Hotline Fix – ZM35-001

Noise from front brake caliper when turning or braking.

Outlander and Outlander PHEV. (7 seat models only – 5 seat models have a different caliper.)

Brake Disc Judgement Flow and Worksheet

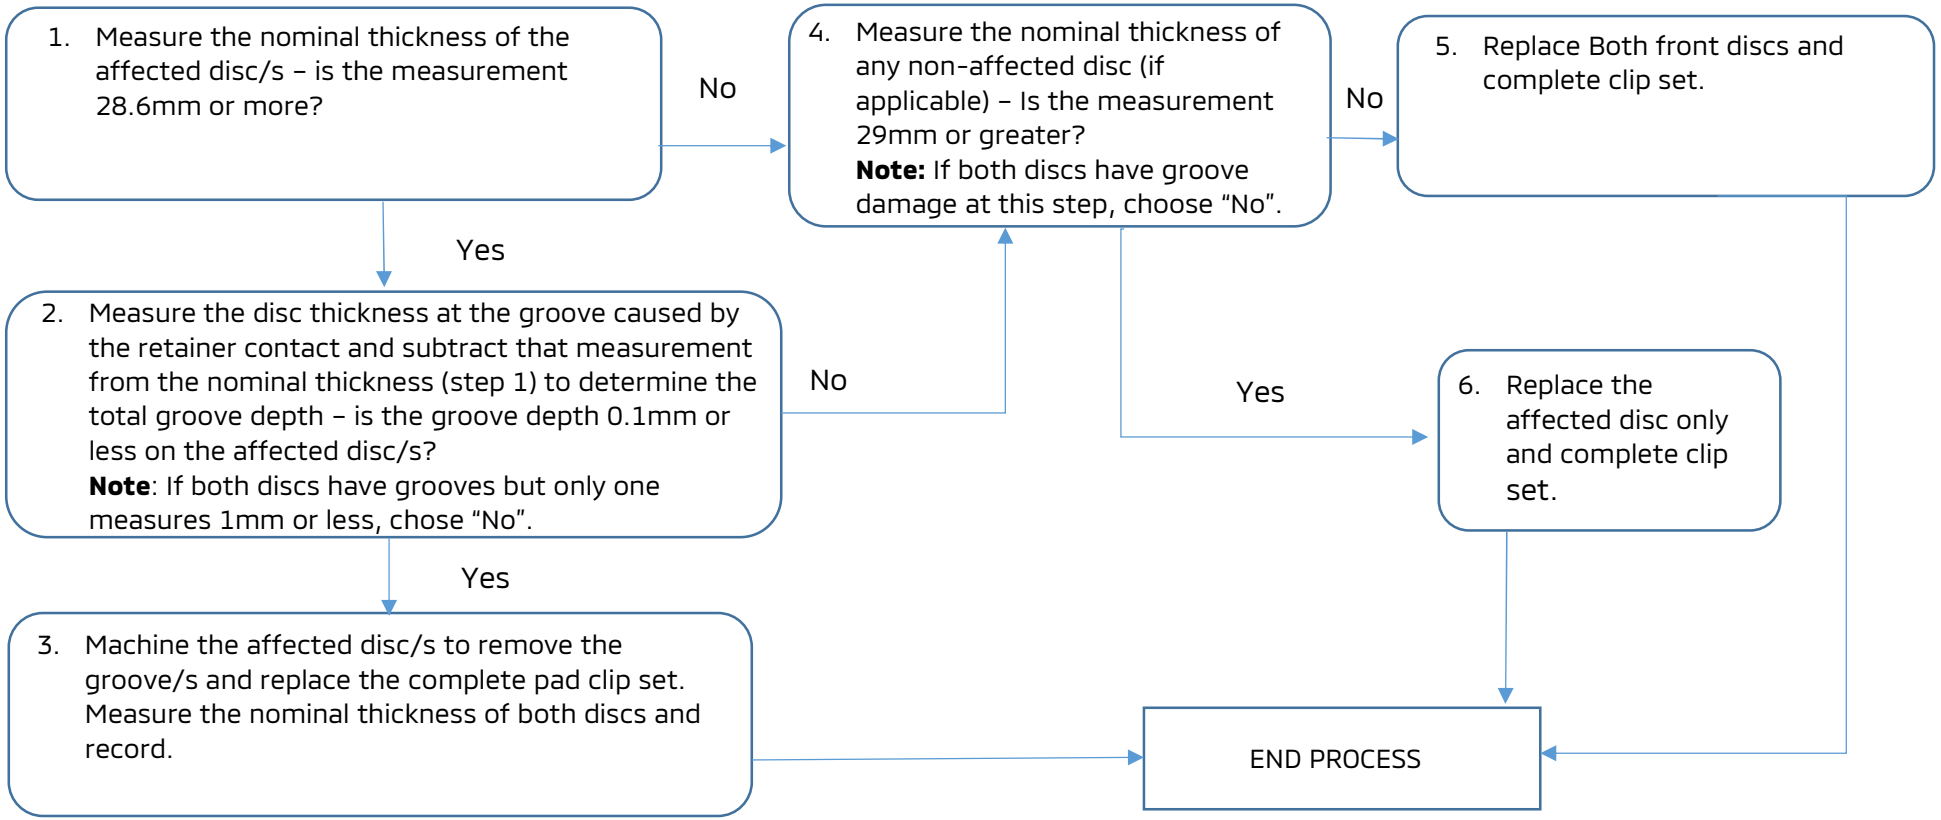
Perform the "Brake Disc Judgement Flow" and photograph the condition of each affected front Brake Disc surface with the "Brake Disc Photo Identification worksheet" VIN and ODOMETER information visible in the photo. Refer example below:

- If the surface of the Brake Disc is consistent with normal wear and tear, no action is required regarding brake disc resurfacing or replacement.
- If the Brake Clip interference has caused damage to the Brake Disc, assess the depth of the resulting groove and determine the appropriate repair as per the work flow on Page 5.
- Photos need to be taken of **both** sides of each disc that is assessed to have damage requiring either machining or replacement.
